**April 17, 2014**  
**BOARD OF COUNTY COMMISSIONERS**  
**ORANGE COUNTY, FLORIDA**  
**Y14-764 MM / ADDENDUM #3**  
**ORANGE COUNTY CONVENTION CENTER WEST BUILDING PHASE 1 HALL D**  
**CATWALK POWER**

**ELECTRICAL:** E1.2.00, E2.5.02, and E5.2.01(Rev 1 dated 4/8/14)

**PARTIAL CONDUIT ROUTING PLANS - LEVEL 3**  
1"=20'-0"  
0 10' 20' 40'

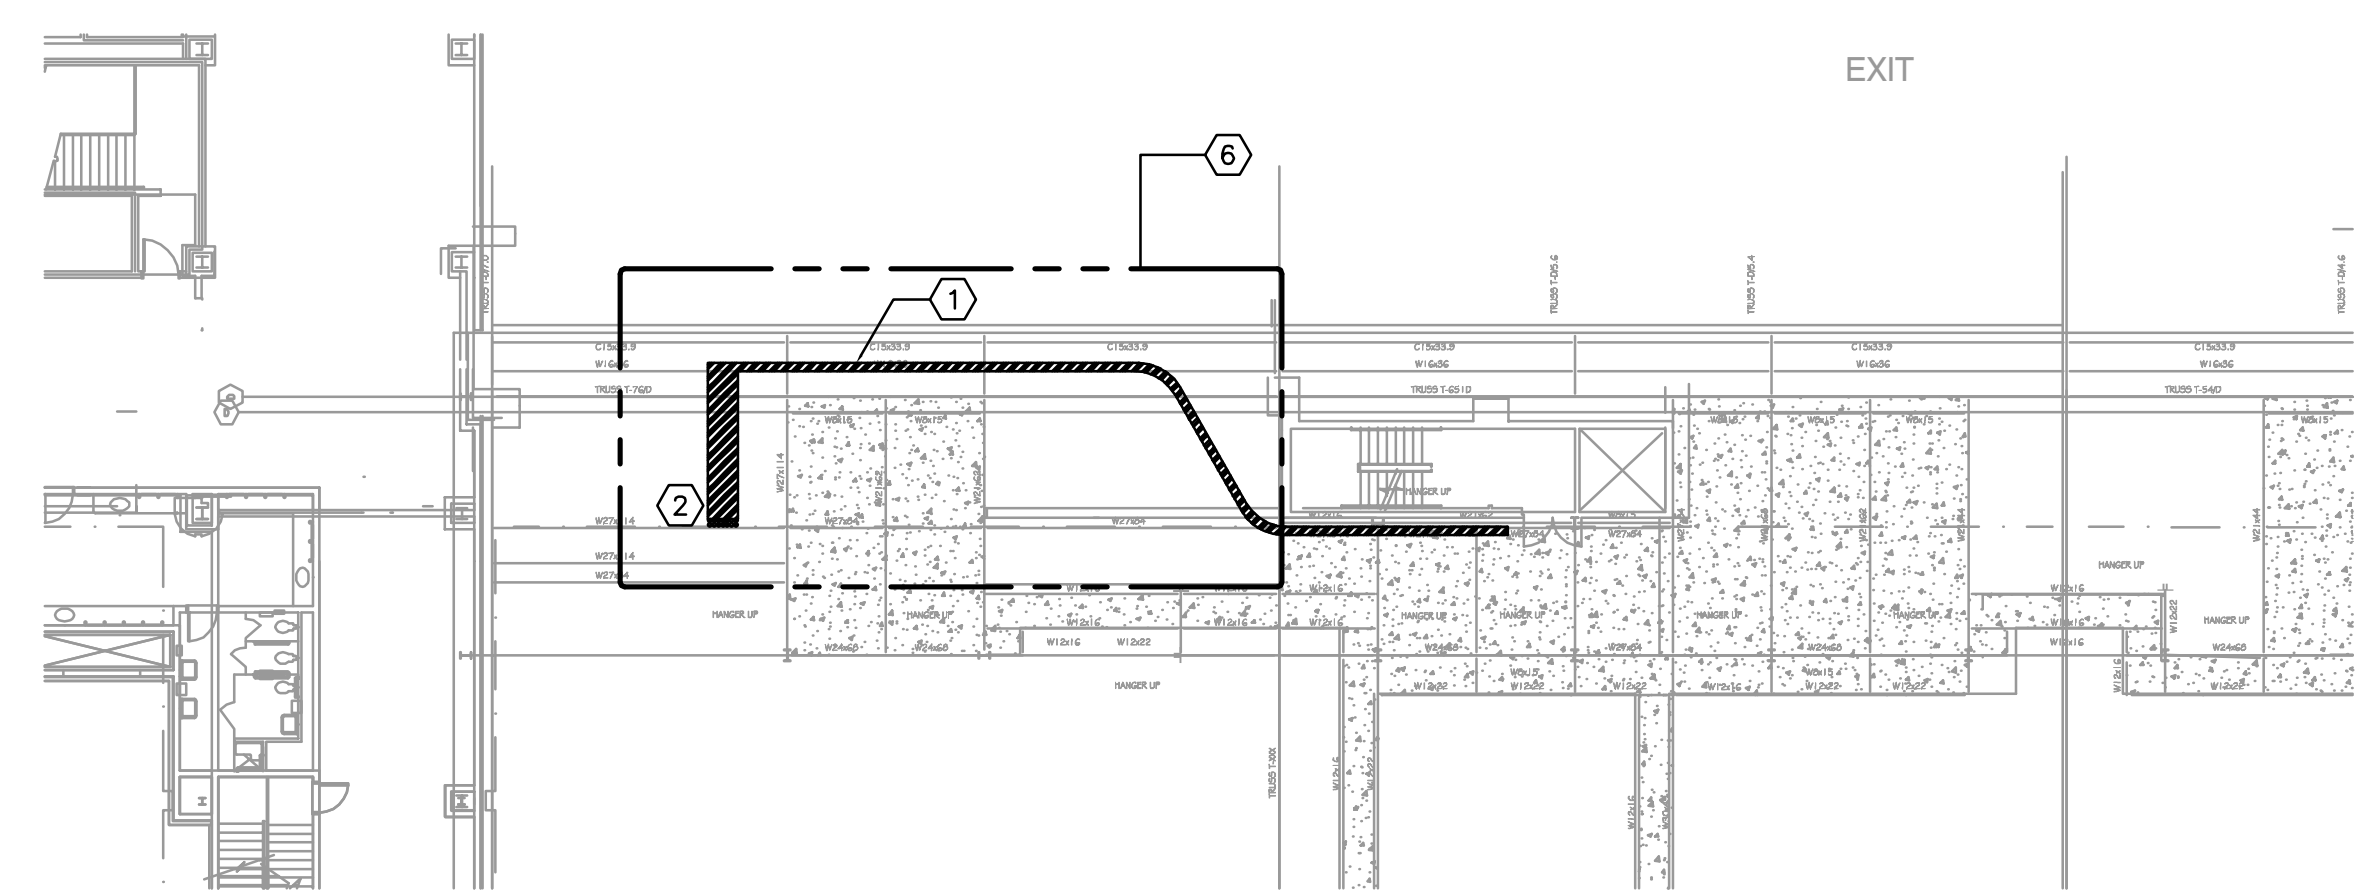
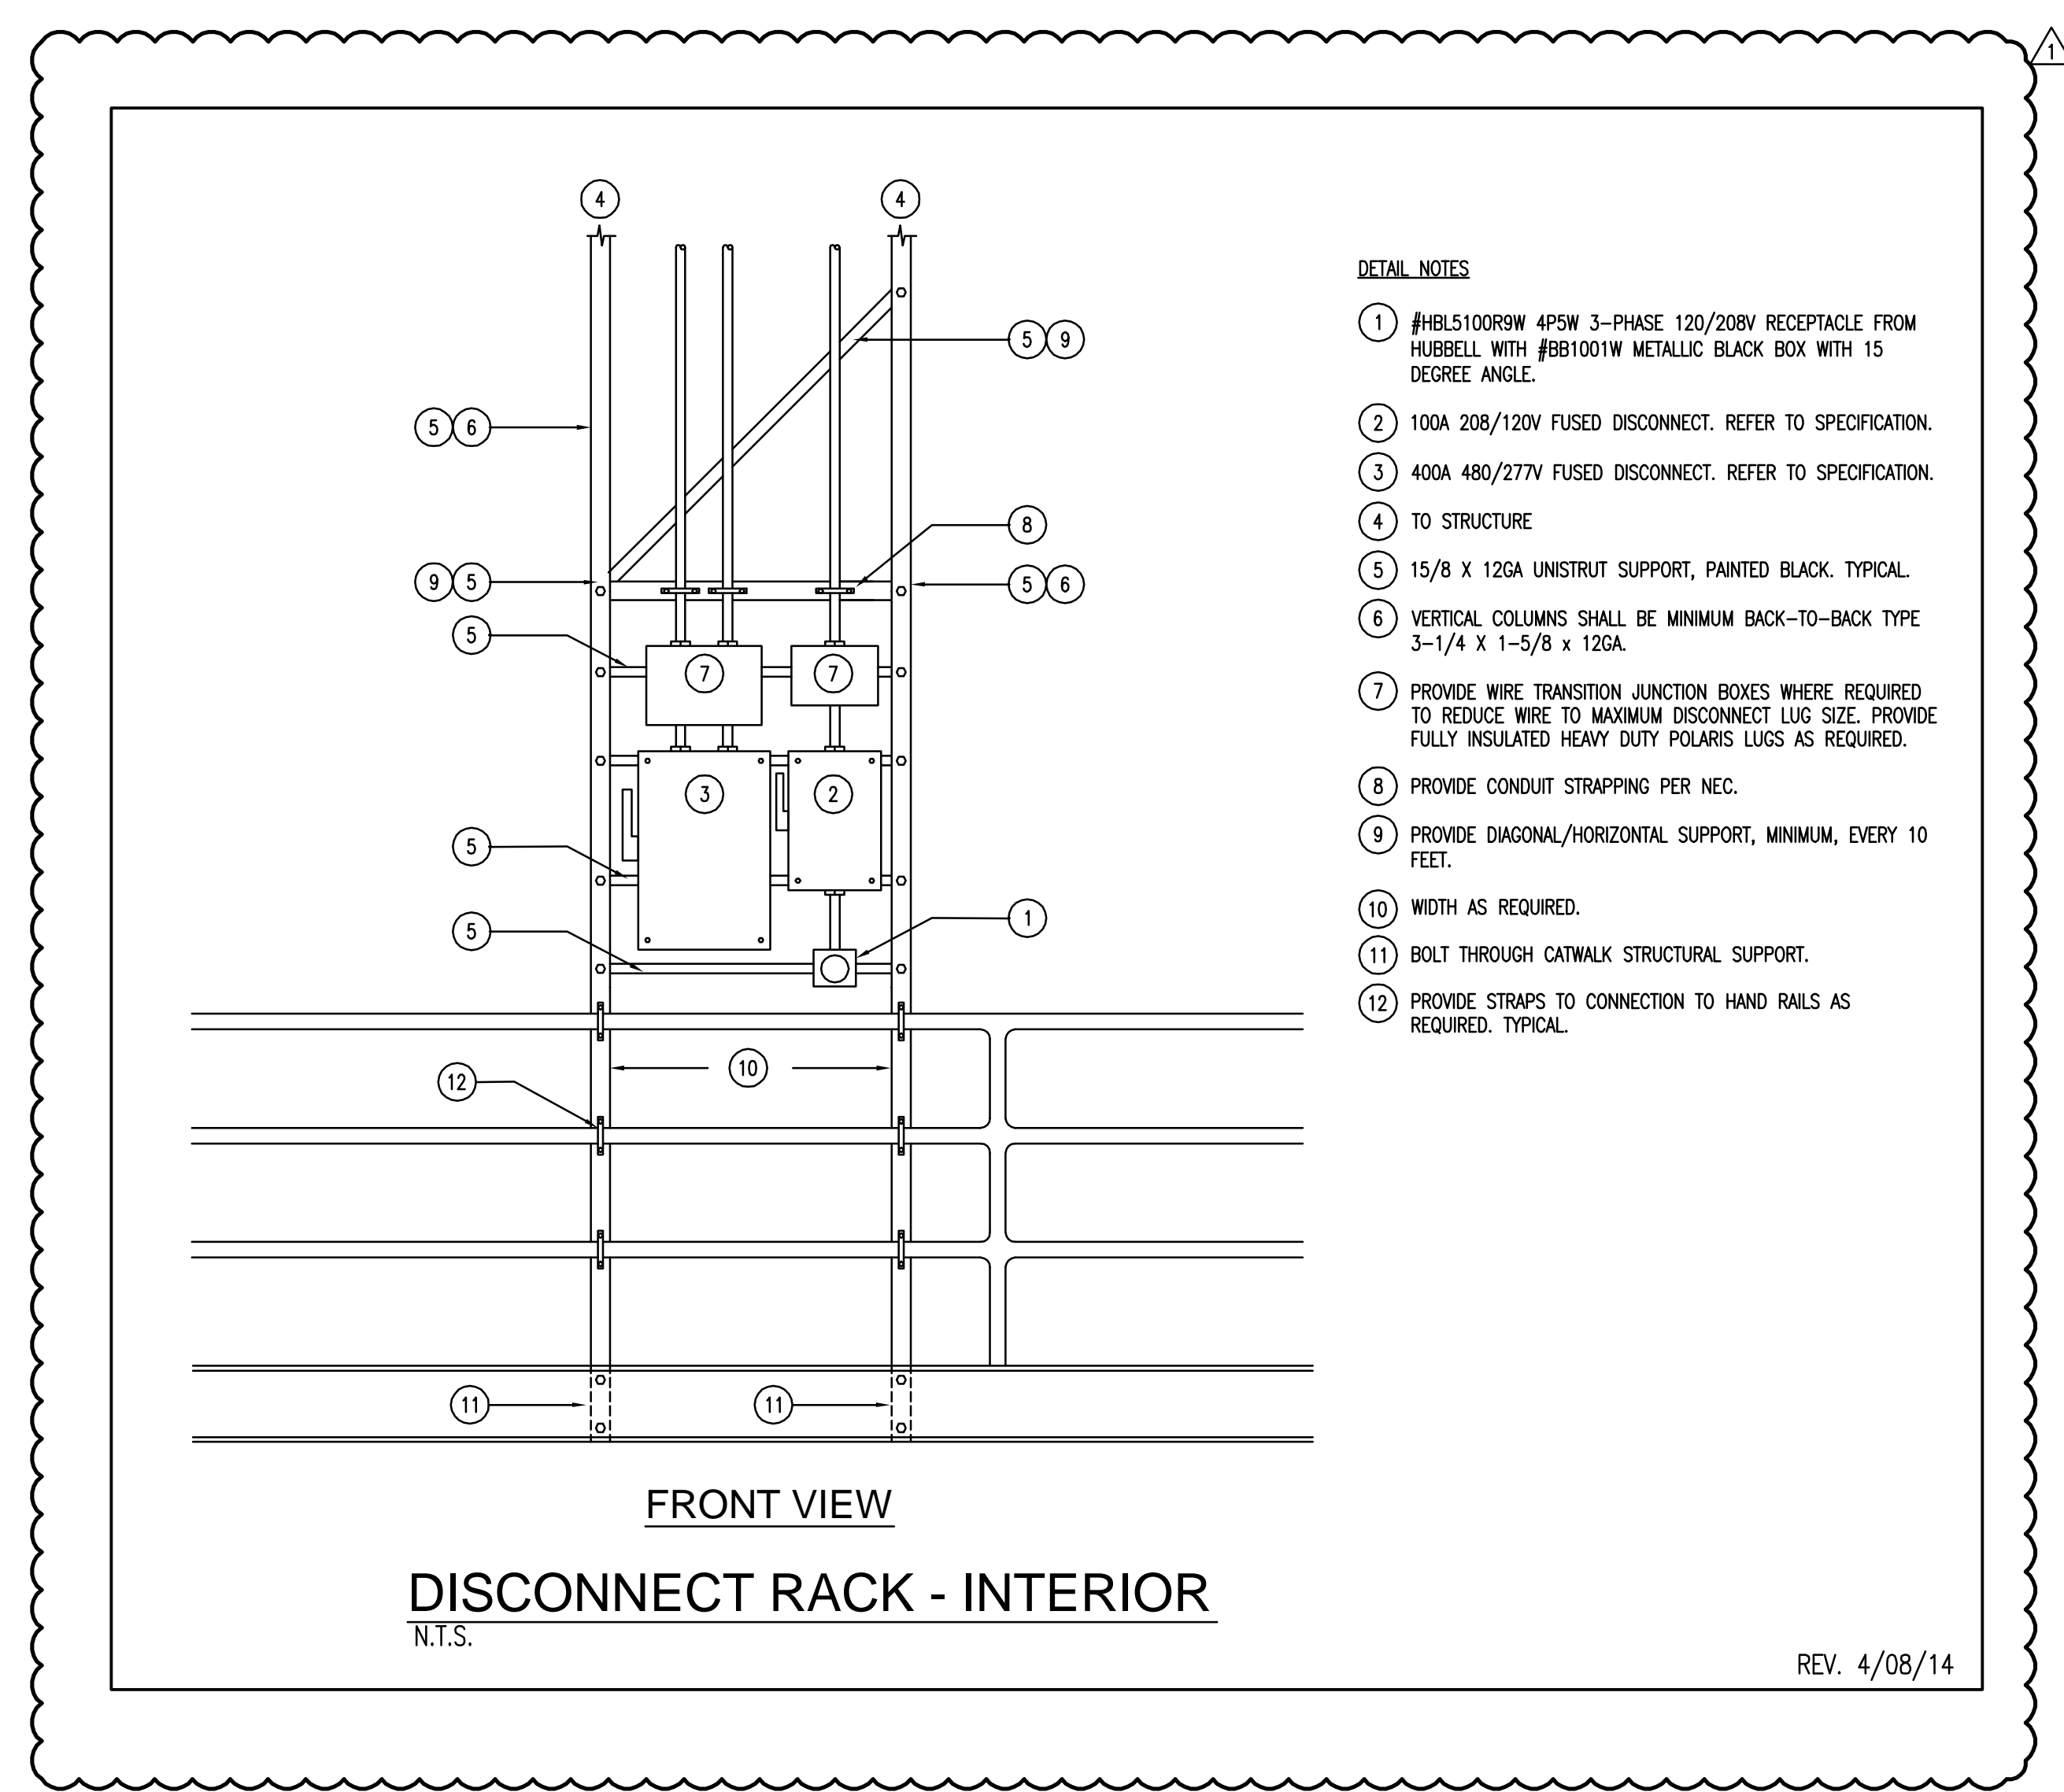
- 15 Upon further inspection the room that the hall divider doors pockets into which was shown to us on the walk thru to turn up in is under the breeze way and not a possible path. I was not able to gain access to the adjacent rooms on either level 2 or 3. There is a 4-5' cavity on the hall side of the divider storage room that has huge steel infrastructure the conduit needs to pass horizontal thru that cavity then turn up. Can someone with access to the rooms meet with us to help us determine what options are possible?

**Response:** Refer to new detail on sheet E5.2.01 for part numbers.
- 19 Please confirm the path in which the feeders are to be installed, from MSB 30 to the new gear location in the mezzanine.

- 33 Pursuant to conversations during the 2<sup>nd</sup> walkthrough, there are some challenges to bringing in the conduit with the suggested route on the plans. During the site visit, it was mentioned that a possible acceptable route would be on the underside of the loading dock ceiling to a point somewhere between trailer dock 45 and ramp #5 on the loading dock, then vertically penetrating the existing ceiling and roof above, then turning toward the exhibit hall and up the new aluca-bond wall system on the exterior and then penetrating into the exhibit hall at the catwalk height. The specifications (16111-6.D.3.a) says conduit is not to be installed on roofs without written authorization by A/E for specific conditions. Would this be an acceptable route?

Sheet E1.2.00 – New Sheet Added – Conduit Routing Plan

**Response:** Probable conduit path shall be shown on the attached new sheet E1.2.00.
- 16 There isn't a spec for the panelboards, is aluminum buss acceptable?

**Response:** Probable conduit path is shown on attached new drawing E1.200.
- 20 Please issue structural and architectural drawings for the walls and floors the 13 conduits (question # 19) are to be run through.

**Response:** Probable conduit path is shown on new attached drawing sheet E1.2.00.
- 27 The Main switchgear is not as listed on the drawing. Could not confirm if the service to this gear is sufficient.

**Response:** Refer to new conduit routing plan on attached sheet E1.2.00.
- 29 Is the framing of the new metal panels on the west elevation above the Level 2 roof sufficient to carry the 13 3.5 rmc.

**Response:** Conduit routing shall be in accordance with new sheet E1.2.00. Conduit on new roof and penetrating new curtain wall system shall not be allowed.

Drawing No. **E5.2.01**

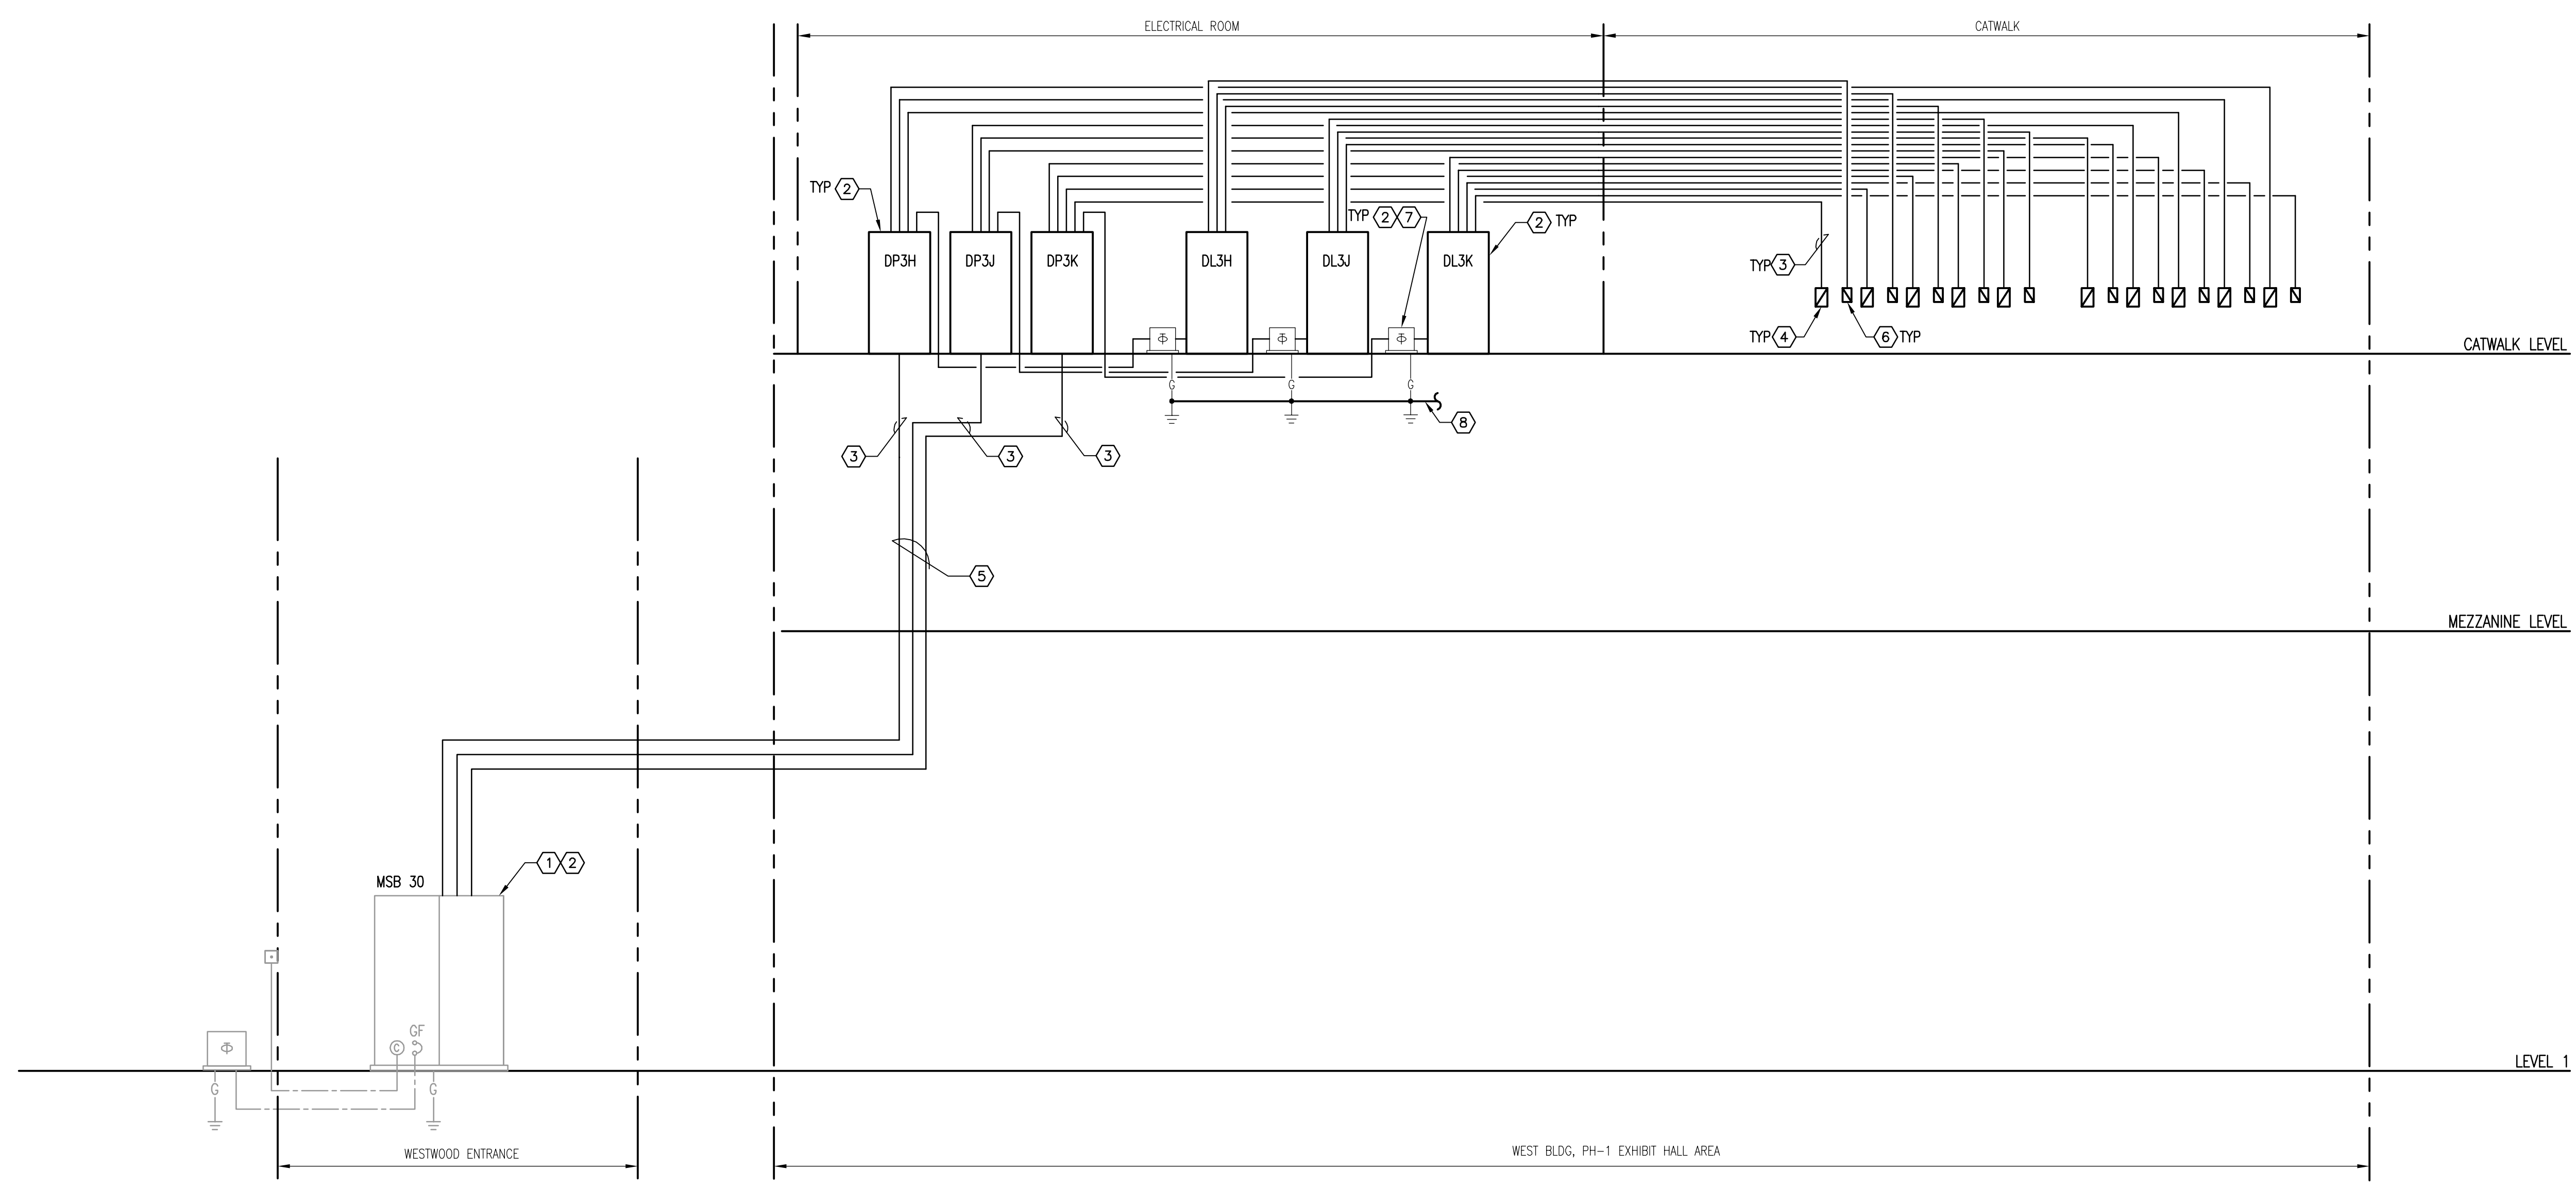
- 4 There is no detail on how to mount the disconnect or receptacle could one be provided?  
**Response:** Yes. Please refer to mounting detail on attached sheet E5.2.01.

- 9 The plans call for 2 disconnects at each location. At the walk thru it was noted that the owner may want a receptacle on the 208/120 feed. Please confirm what is correct and what type of receptacle if required.

**Response:** Refer to attached specification section 16461.
- 18 Plans call for Hubbell pin and sleeve disconnects on sheet E5.2.01 but there is no spec for this or part # on plans. Please send spec info and part # for this.

Sheet E5.2.01 – Added Disconnect mounting and receptacle detail

**Response:** Please refer to new detail on sheet E5.2.01.
- 10 Provide specifications for the following:  
a. Switchboards.  
**Response:** Switchboard is existing so it is not required.

**Response:** .Probable conduit path is shown on attached new drawing E1.200.
- 21 Please confirm fused/nonfused disconnects.  
**Response:** Fused disconnects. Refer to new detail on sheet E5.2.01
